REMARKS

ANNOTATED SHEET SHOWING CHANGES

FIG. 2

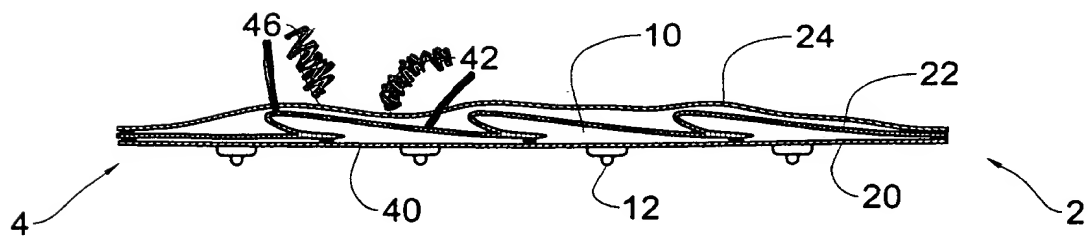
Applicant has enclosed herewith amended Figs. 2 and 3 which correct the identification of elements 42 and 46.
